Transport for London

London Underground

Re: Review and approval of 2026, 2026+28% AM and PM Peak SDCC (RIBA E design) LU-IM Crossrail Station Legion models and accompanying reports: design suitability from a passenger flow perspective

This letter summarises our agreed position with regards to the technical audits of the Crossrail LU-IM station complex models and their associated RIBA E Stage Design Compliance Certificate (SDCC) modelling reports.

TOTTENHAM COURT ROAD

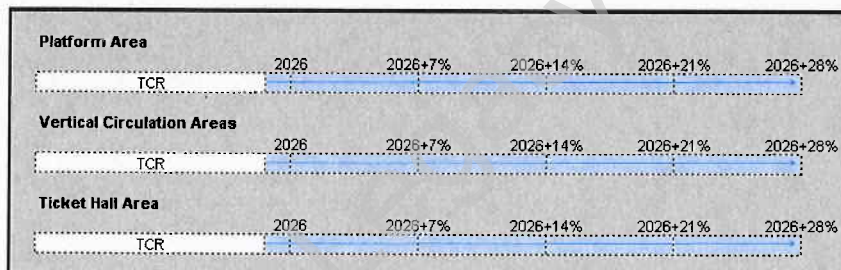
- No Issues arising from reviewing this report
- Hence no breakpoints/mitigations identified
- Option DI.8 model from the Project Assure workstream is carried through as the base model
- Additionally:** On existing infrastructure (post LU upgrade) the middle of the three Northern Line staircases shows as being particularly over utilised with density levels higher than what is deemed acceptable in both the AM and PM Peak 2026+28% scenarios. Due to the staircases in this area being predominantly signed as one way and an extensive process of modelling to find the optimal configuration for these stairs mitigations are somewhat limited. However, if levels of queuing and congestion did become too high on the middle stair then to help relieve this it would be advisable to make use of the bottom bi-directional stair and direct a proportion of passengers this way to leave the SB platform.

WHITECHAPEL

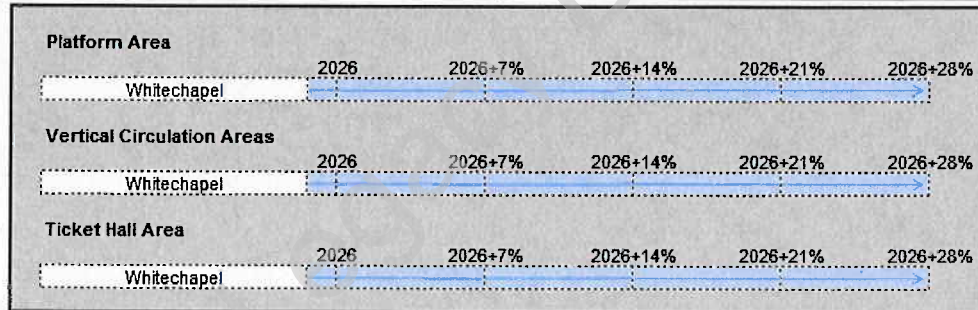
- Hence no Interventions/mitigations identified
- Additionally:=
- On existing infrastructure** there is a known problem with ELL SB platform in the PM Peak, platforms were not widened as part of CRL build and are known to be narrow. Intervention such as station control / comms will be needed during peak periods in PM Peak. These issues may be assisted through "Project Bold" which will increase the length of ELL trains by adding an additional car.

- Model currently assumes 70% of passengers always board the first ELL SB train (and make movements at stations such as Canada Water to board train of choice). With this optimistic measure in place platform density in peak fifteen minutes is still showing up a just over unacceptable.

- Alternative mitigation for ELL SB platform has been identified as a one way system with access from the northern stairs and egress from the southern stair. However, the overall platform density and length of time that passengers experience unacceptable densities does not significantly improve.

- Due to pulsing from train arrivals on the ELL platforms the existing Stairs connecting the ELL NB and HCDL platforms show unacceptable LOS E in AM Peak which is likely to cause delays to these interchange passengers

TCR

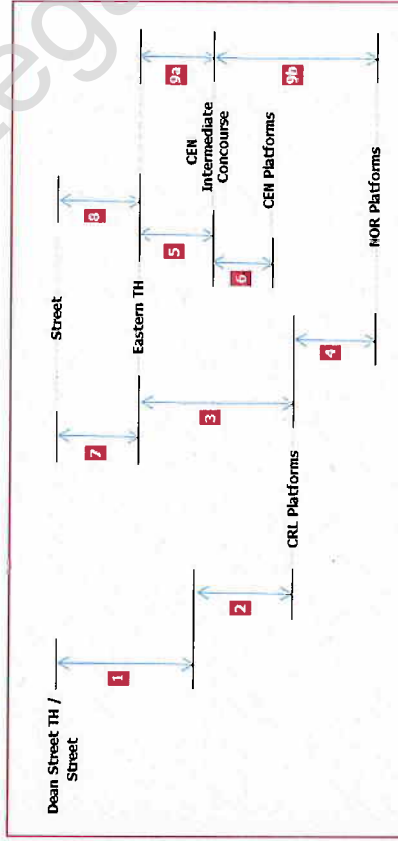
2026+28% Demand Levels		Static Assessment assuming capacity of lift ~ 70% of plated capacity	
	AM	PM	
1	✓	✓	Up: {100%, 100%} Down: {100%, 33%}
2	✓	✓	Up: {100%, 100%} Down: {100%, 30%}
3	✓	✓	Up: {100%, 100%} Down: {100%, 18%}
4	✓	✓	Up: {100%, 100%} Down: {100%, 72%}
5	✓	✓	Up: {100%, 100%} Down: {100%, 74%}
6	✓	✓	Up: {100%, 100%} Down: {100%, 54%}
7	✓	✓	Up: {100%, 100%} Down: {100%, 59%}
8	✓	✓	Up: {100%, 100%} Down: {100%, 59%}
9a	✓	✓	Assumed not to be in use
9b	✓	✓	Up: {100%, 100%} Down: {100%, 52%}

LIFT STATIC ASSESSMENTS (2 of 3)

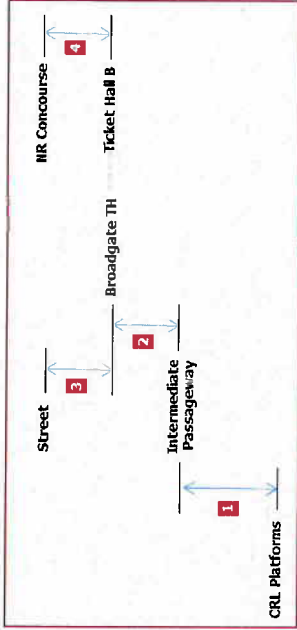
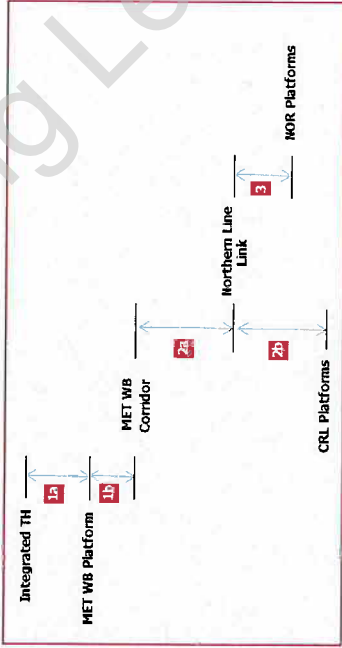
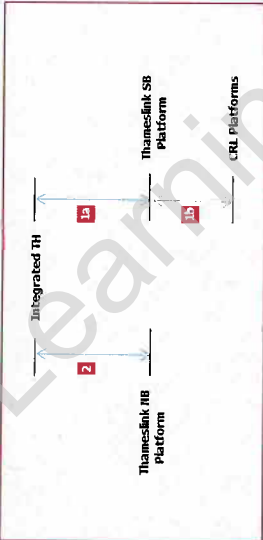
2026+28% Demand Levels	Static Assessment assuming capacity of lift ~ 70% of plated capacity	
	AM	PM
1a	✓	✓
1b	✓	✓
2	✓	✓
2026+28% Demand Levels	Static Assessment assuming capacity of lift ~ 70% of plated capacity	
1a	✓	✗
1b	✓	✓
2a	✓	✗
2b	✓	✗
3	✓	✓
2026+28% Demand Levels	Static Assessment assuming capacity of lift ~ 70% of plated capacity	
1	✓	✓
2	✓	✓
3	✓	✓
4	✓	✓

WCL

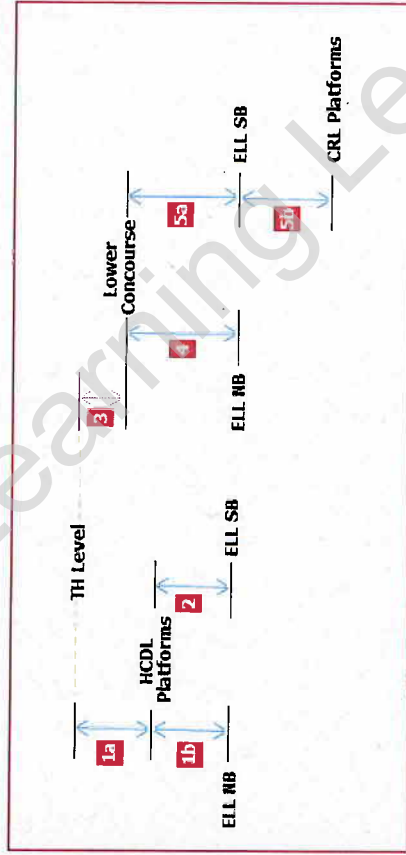
2026+28% Demand Levels		Static Assessment assuming capacity of lift = 70% of plated capacity		
	AM	PM	AM	PM
1a	✓	✓	Up: {100%, 100%} Down: {100%, 100%}	Up: {100%, 70%} Down: {100%, 48%}
1b	✓	✓	Up: {100%, 100%} Down: {100%, 100%}	Up: {100%, 100%} Down: {100%, 100%}
2	✓	✓	Up: {100%, 100%} Down: {100%, 100%}	Up: {100%, 100%} Down: {100%, 100%}
3	✓	✓	Up: {100%, 100%} Down: {100%, 100%}	Up: {100%, 100%} Down: {100%, 100%}
4	✓	✓	Up: {100%, 100%} Down: {100%, 100%}	Up: {100%, 100%} Down: {100%, 100%}
5a	✓	✓	Up: {100%, 100%} Down: {100%, 100%}	Up: {100%, 35%} Down: {100%, 47%}
5b	✓	✓	Up: {100%, 100%} Down: {100%, 100%}	Up: {100%, 14%} Down: {100%, 38%}
